Door replacement

DESCRIPTION:

Pict.1 The drawer which could not be mounted in new door

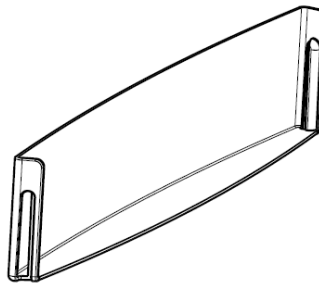
New doors are created to replace previous one with changed innerliner. Due to new innerliner door shelf shown in the picture Pict.1, which could be found in some appliances will not be possible to mount.

Pict.2 A- the old door; B- the new door

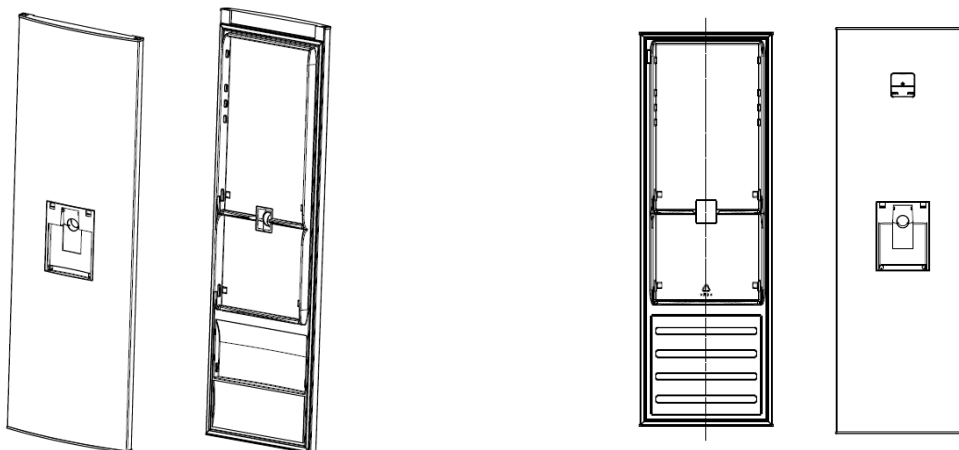
Doors included in left column of Tab.1 will not be available anymore because of quality issues related to its innerliner shape.

The difference between old and new doors is visible (Pict.2.)
